**LANDMARK COMMISSION****AUGUST 3, 2026**

FILE NUMBER: COA-26-000360
LOCATION: 3503 Meyers St.
STRUCTURE: Contributing
COUNCIL DISTRICT: 7
ZONING: PD-595

1. A Certificate of Appropriateness to replace windows (total 20) on all four elevations and to restore window fenestration on front facade.
2. A Certificate of Appropriateness for the construction of a rear horizontal addition to the main building.

ELEVATIONS

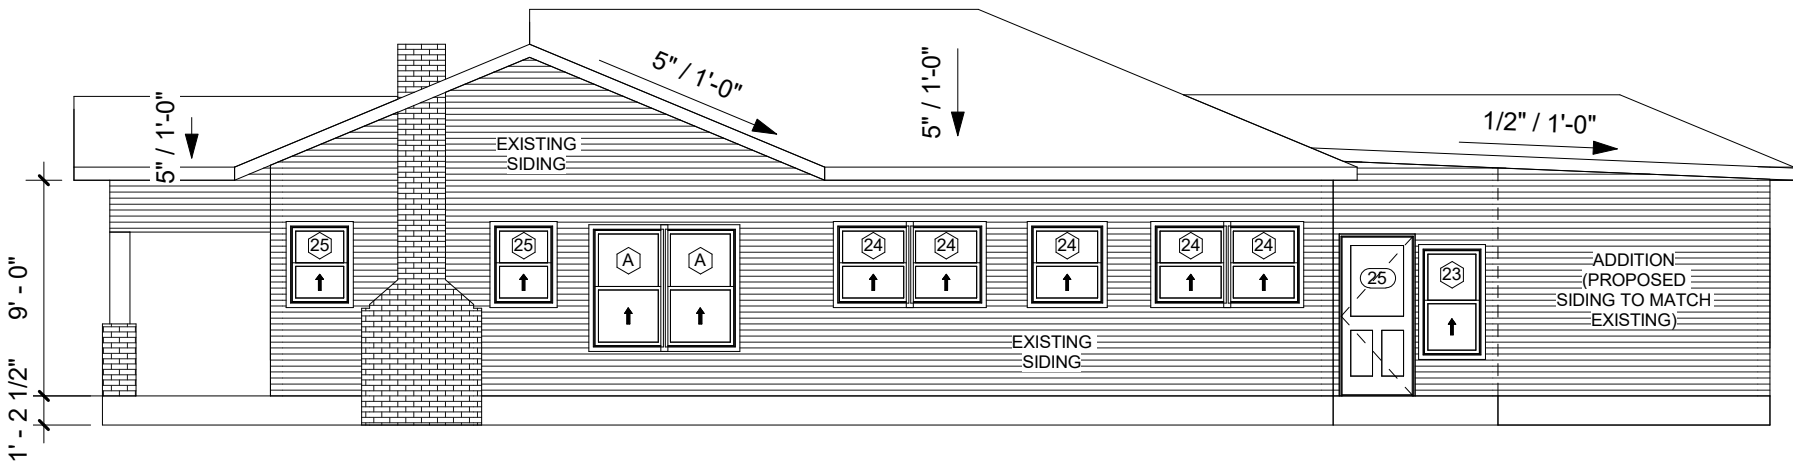
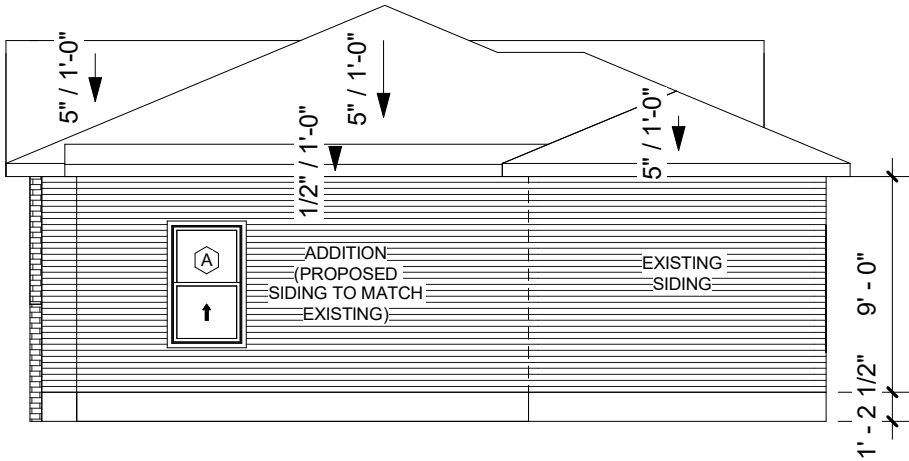
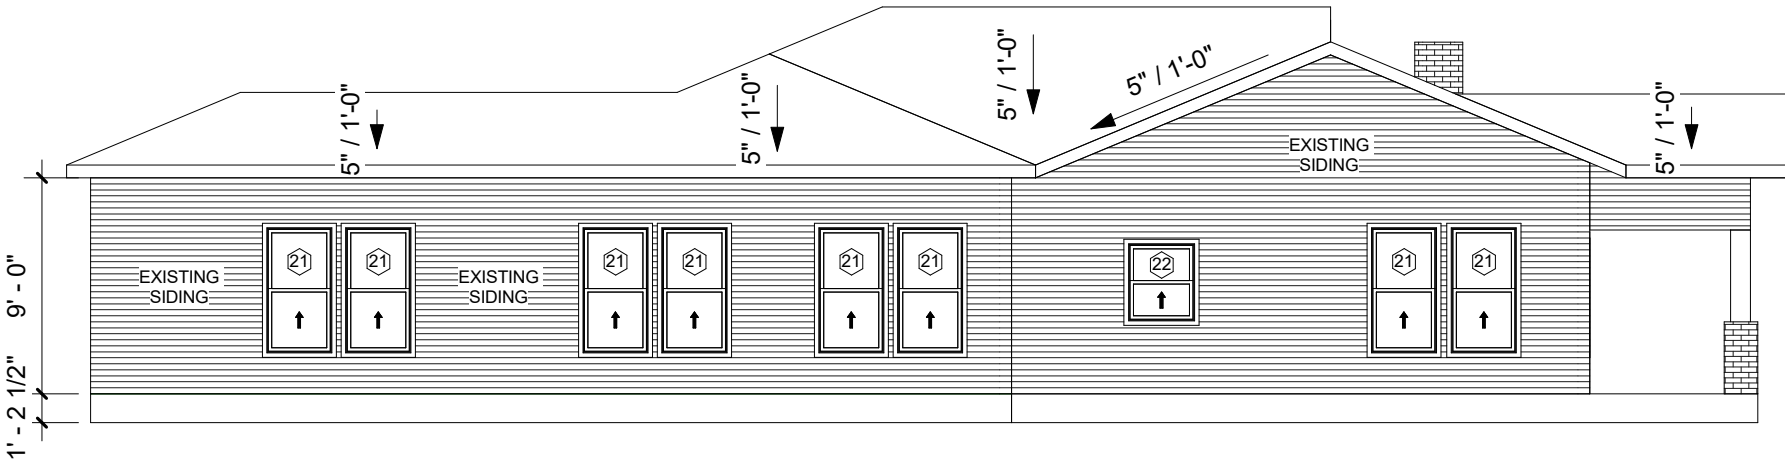
The applicant also proposes construction of a rear addition attached to an earlier non-original addition. While the rear-yard placement and overall massing of the new addition are appropriate under district criteria, the proposed continuation of the earlier addition's shed roofline is not compatible with the historic gable roof of the main structure. The roofline of the new work must align with or continue the principal roof form of the original building.

The applicant proposes replacing all windows and resizing only the two front windows to create a fenestration pattern consistent with other contributing houses. Because all other openings remain unchanged in size and placement, the revised front elevation maintains an appropriate solid-to-void relationship. Staff concludes that the selective resizing is compatible with district character when limited to the front façade and when replacement windows on the front and cornerside elevations are wood.

New construction in the rear yard is permitted under Section 9 of the Wheatley Place criteria. Additions must be compatible in massing, materials, roof form, and detailing. The proposed rear addition meets placement and scale requirements, but extending the shed roof of the earlier addition does not meet the compatibility standard. The district criteria require additions to reflect the slope and configuration of the main roof to maintain the historic massing of the structure.

Aligning the new addition's roof with the original gable roof will correct this inconsistency and ensure compatibility with the district's established architectural pattern.

2. That the request for a Certificate of Appropriateness for the construction of a rear horizontal addition to the main building be approved in accordance with drawings and specifications dated 7/17/2026 with the following conditions: that the exterior siding be all wood horizontal lap-siding millwork pattern #117 to matching the existing; that the

foundation be pier and beam and at the same height as the existing foundation; and that the cornerside roofline be aligned with that of the original main building. Implementation of the recommended conditions would allow the proposed work to be consistent with preservation criteria Sections 9.1 – 9.7 under New Construction and Additions requiring compatibility in massing, materials, color, roof form, and detailing; the standards in City Code Section 51-4.501(g)(6)(C)(i) for contributing structures; and the Secretary of the Interior's Standards for Rehabilitation.
